MONTGOMERY COUNTY PLANNING DEPARTMENT
THE MARYLAND-NATIONAL CAPITAL PARK AND PLANNING COMMISSION

MEMORANDUM

REVIEW TYPE: Preliminary Plan of Subdivision

PROJECT NAME: Village of Chevy Chase
CASE #: 120080180
REVIEW BASIS: Chapter 50, Montgomery County Subdivision Regulations

FILE 1-20080180
 PROPOSED LOTS 28-29, BLOCK 2
 VILLAGE OF CHEVY CHASE, SECTION 3
 NEIGHBORHOOD MAP

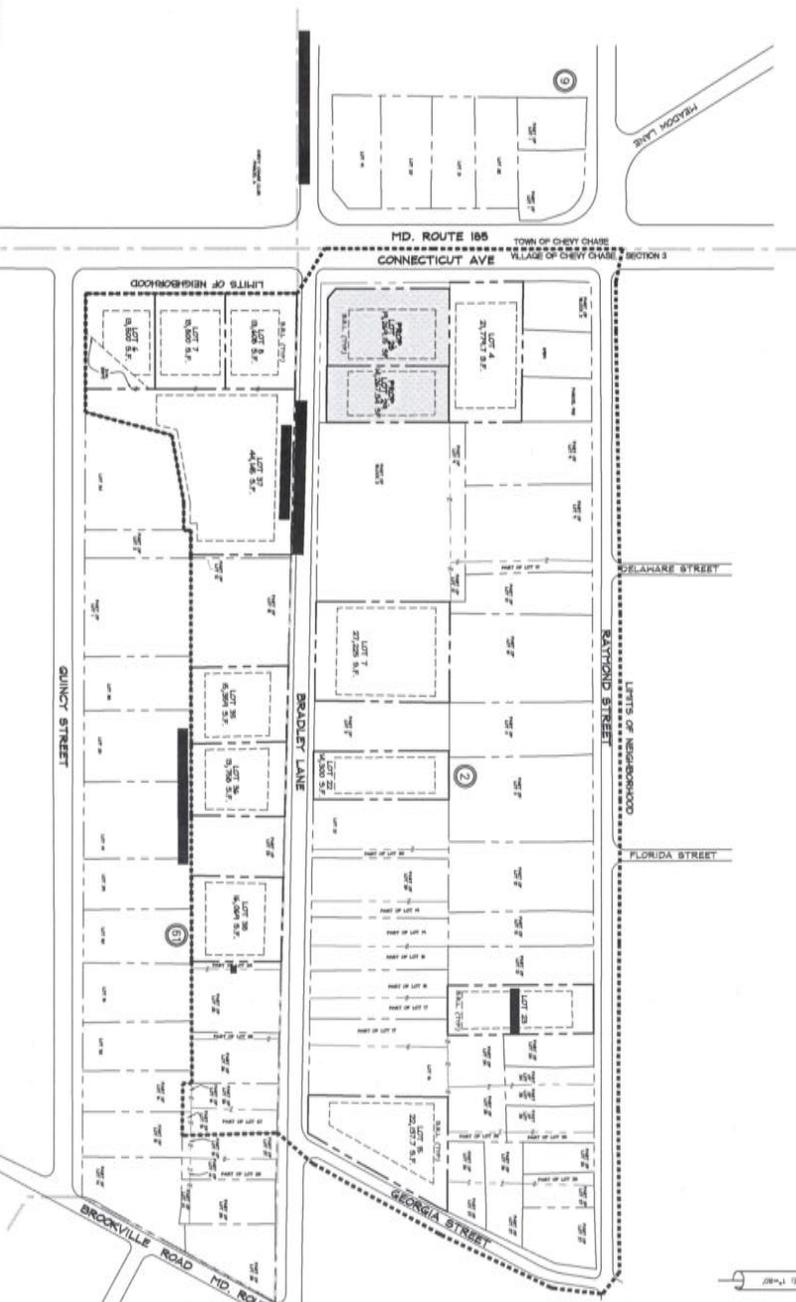
In performing the analysis, the above-noted resubdivision criteria were applied to the delineated neighborhood. The proposed lots are of the same character with respect to the resubdivision criteria as other lots within the defined neighborhood. Therefore, the proposed resubdivision complies with the criteria of Section 50-2(b)(2). As set forth below, the attached tabular summary and graphical documentation support this conclusion:

In a neighborhood of 12 lots, lot frontages range from 70 feet to 238 feet. Two of the lots have frontages of 70 feet, eight lots have frontages between 100 and 139 feet, and the remaining two lots have frontages of more than 200 feet. Proposed Lot 28 has a frontage of 110 feet on Bradley Lane and 175 feet on Connecticut Avenue, and Proposed Lot 29 has a frontage of 80 feet on Bradley Lane. Although proposed Lot 29 is at the lower end of the range for lot frontage, it is ten feet wider than the two most narrow lots, and ten feet is a significant amount in the R-60 zone. **The proposed lots will be of the same character as existing lots in the neighborhood with respect to lot frontage.**

All 12 of the existing lots in the neighborhood are perpendicular in alignment. The two proposed lots are also perpendicular. **The proposed lots are of the same character as existing lots with respect to the alignment criterion.**

The lots in the delineated neighborhood range from 13,500 square feet to 44,145 square feet. Four of the lots are between 13,000 and 14,000 square feet, four are between 14,000 and 17,000 square feet, and four are between 21,000 and 45,000 square feet. Proposed Lot 28 is 19,269 square feet in size and Proposed Lot 29 is 14,267 square feet in size. **The proposed lot sizes are in character with the size of existing lots in the neighborhood.**

Ten of the existing lots in the neighborhood are rectangular, and the remaining two lots are irregularly shaped. The two proposed lots are rectangular. **The shapes of the proposed lots will be in character with shapes of the existing lots.**

The lots in the delineated neighborhood range from 70 feet to 235 feet in width. Two of the lots have widths of 70 feet, eight lots have widths between 100 and 139 feet, and the remaining two lots have widths of more than 200 feet. Proposed Lot 28 has a width of 110 feet and Proposed Lot 29 has a width of 80 feet. Although proposed Lot 29 is at the lower end of the range for lot width, it is ten feet wider than the two most narrow lots, and ten feet is a significant amount in the R-60 zone. **The proposed lots will be in character with existing lots in the neighborhood with respect to width.**

The lots in the delineated neighborhood range from 5,151 square feet to 27,916 square feet in buildable area. Five of the lots have a buildable area between 5,000 and 8,000 square feet, three are between 8,000 and 9,000 square feet, and four are between 10,000 and 28,000 square feet. Proposed Lot 28 has a buildable area of 8,844 square feet and Proposed Lot 29 has a buildable area of 7,955 square feet. **The proposed lots will be of the same character as other lots in the neighborhood with respect to buildable area.**
